SOIL/SITE EVALUATION for ON-SITE WASTEWATER SYSTEM

TRACT 4
ARLINGTON ACRES – MAP 1
MINT HILL, MECKLENBURG COUNTY, NORTH CAROLINA

IMPROVEMENT PERMIT for a RESIDENTIAL ON-SITE WASTEWATER TREATMENT & DISPOSAL SYSTEM

Permit #: **30008578** GWS File #: **9611B** Tax Parcel #: **139-281-20**

On-site Wastewater Improvement Permit Diagram

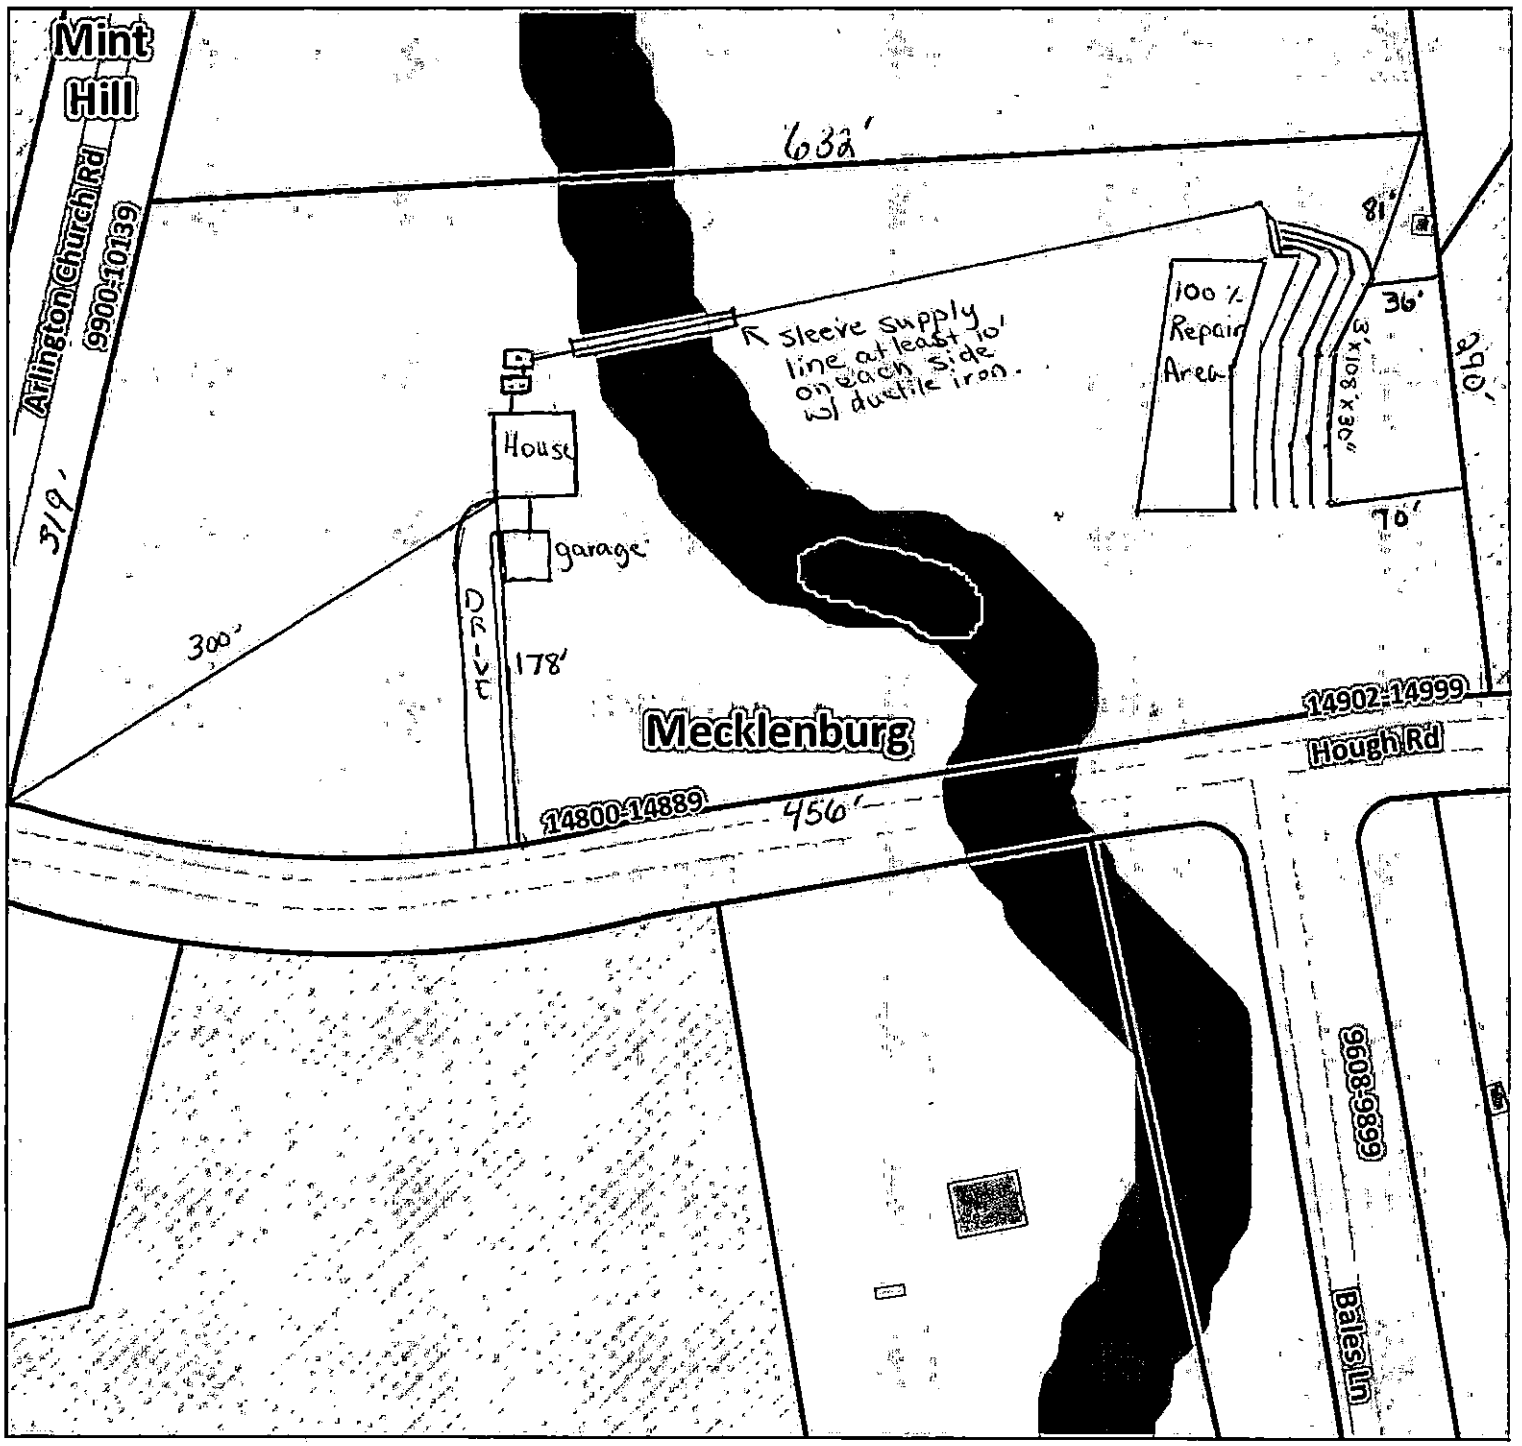
Improvement Permit/Construction Authorization: 130A-336(a)(1) - Property line lengths shown?	No
Improvement Permit/Construction Authorization: 130A-336(a) - Facility/appurtenance setbacks shown from fixed points?	Yes
Corrections/modifications needed?	Yes
Comments:	Insert property line lengths.
IA issued date:	
OP Issued date:	
Review performed by:	Jeremy Michael
Date performed:	11/28/2016
